Title - Sujet New Residence Nouvelle résidence	
Solicitation No. - N° de l'invitation EZ899-220930/A	Amendment No. - N° modif. 003
Client Reference No. - N° de référence du client	Date 2021-09-03
GETS Reference No. - N° de référence de SEAG PW-SPWY-031-9034	
File No. - N° de dossier PWY-1-44072 (031)	CCC No./N° CCC - FMS No./N° VME
Solicitation Closes - L'invitation prend fin at - à 02:00 PM Pacific Daylight Saving Time PDT on - le 2021-09-09 Heure Avancée du Pacifique HAP	
F.O.B. - F.A.B. Plant-Usine: <input type="checkbox"/> Destination: <input checked="" type="checkbox"/> Other-Autre: <input type="checkbox"/>	
Address Enquiries to: - Adresser toutes questions à: Leung, Janie	Buyer Id - Id de l'acheteur pwy031
Telephone No. - N° de téléphone (778) 919-3273 ()	FAX No. - N° de FAX () -
Destination - of Goods, Services, and Construction: Destination - des biens, services et construction: RCMP – New Residence – New Aiyansh, BC

This Amendment 003 is raised:

Addendum 03
2021-09-02

Project:	New Residence, New Aiyansh, BC	Addendum No.:	S-01
Project No.:	211-02781-00	Date:	2021-September-02
Distribution:	PSPC, Number Ten

2 BASEMENT PLAN SHOWING MAIN FLOOR FRAMING OVER
S-2.01 SCALE: 1:50

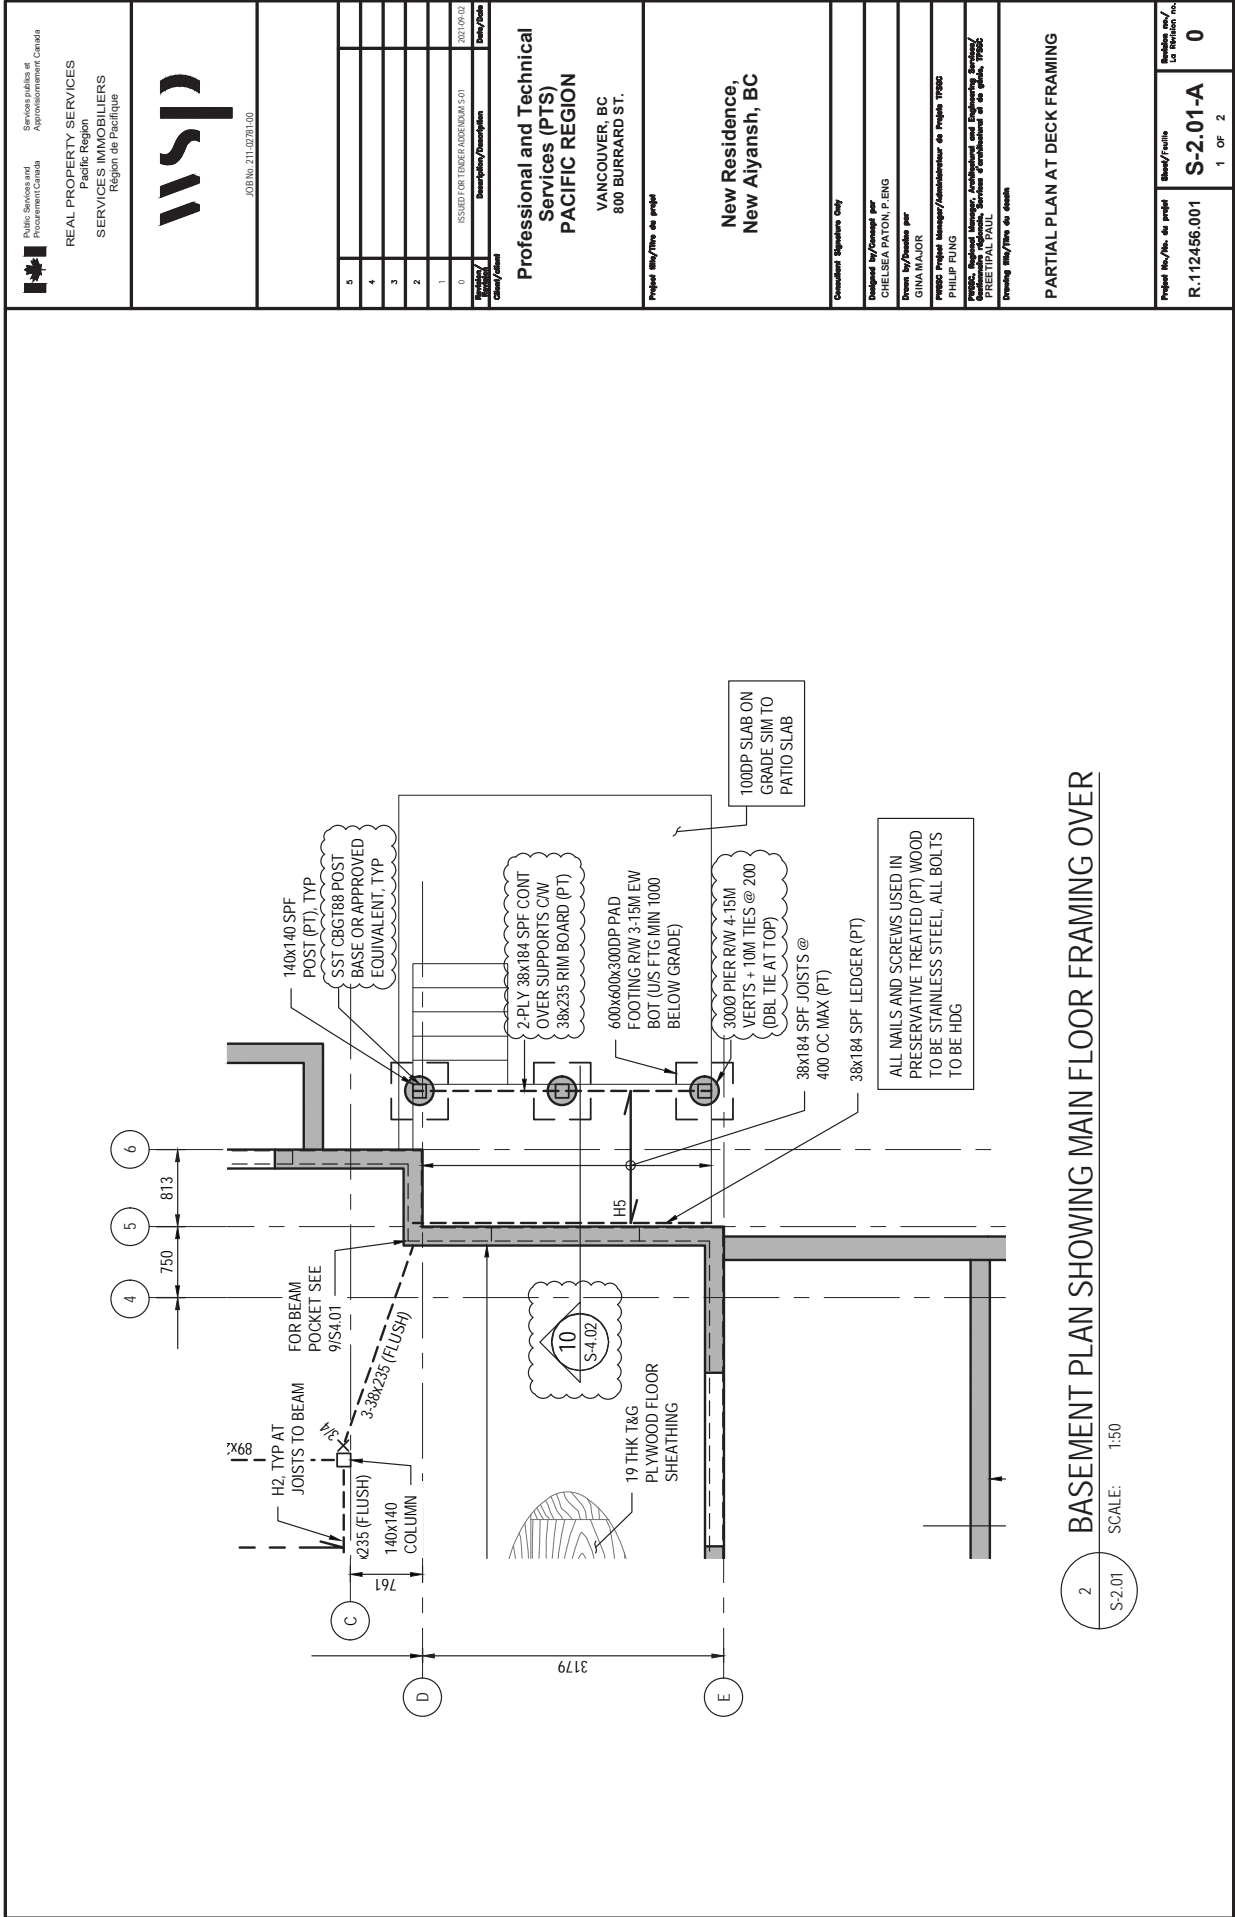
- 1 Refer to attached drawings S-2.01-A and S-4.02-A for wood-framed deck details.
